**Economic and Social Council**Distr.: General
7 April 2011

Economic Commission for Europe**Inland Transport Committee****World Forum for Harmonization of Vehicle Regulations****154th session**

**1958 Agreement – Consideration of draft amendments
to existing Regulations submitted by GRPE****Proposal for Supplement 2 to the 06 series of amendments to
Regulation No. 83 (Emissions of M₁ and N₁ vehicles)****Submitted by the Working Party on Pollution and Energy***

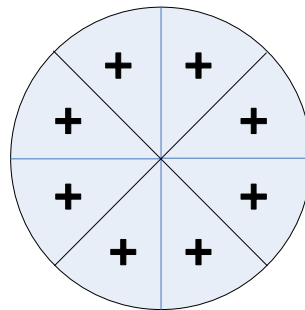
Annex 4, paragraph 6.1.3., amend to read:

- (a) For blowers with rectangular outlets are located at the centre of each rectangle dividing the whole of the blower outlet into 9 areas (dividing both horizontal and vertical sides of the blower outlet into 3 equal parts). The centre area shall not be measured (as shown in the diagram below).

"6.1.3. A current of air of variable speed shall be blown over the vehicle. The blower speed shall be within the operating range of 10 km/h to at least the maximum speed of the test cycle being used. The linear velocity of the air at the blower outlet shall be within ± 5 km/h of the corresponding roller speed within the range of 10 km/h to 50 km/h. At the range over 50 km/h, the linear velocity of the air shall be within ± 10 km/h of the corresponding roller speed. At roller speeds of less than 10 km/h, air velocity may be zero.

The above mentioned air velocity shall be determined as an averaged value of a number of measuring points which

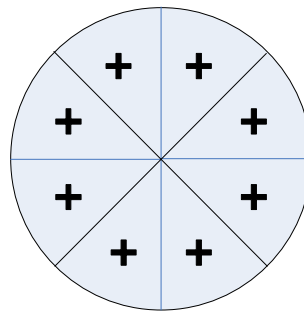
Annex 4a, paragraph 3.4.2., amend to read:

- (a) For blowers with rectangular outlets are located at the centre of each rectangle dividing the whole of the blower outlet into 9 areas (dividing both horizontal and vertical sides of the blower outlet into 3 equal parts). The centre area shall not be measured (as shown in the diagram below).

"3.4.2. A current of air of variable speed shall be blown over the vehicle. The blower speed shall be, within the operating range of 10 km/h to at least the maximum speed of the test cycle being used. The linear velocity of the air at the blower outlet shall be within ± 5 km/h of the corresponding roller speed within the range of 10 km/h to 50 km/h. At the range over 50 km/h, the linear velocity of the air shall be within ± 10 km/h of the corresponding roller speed. At roller speeds of less than 10 km/h, air velocity may be zero.

The above mentioned air velocity shall be determined as an averaged value of a number of measuring points which:
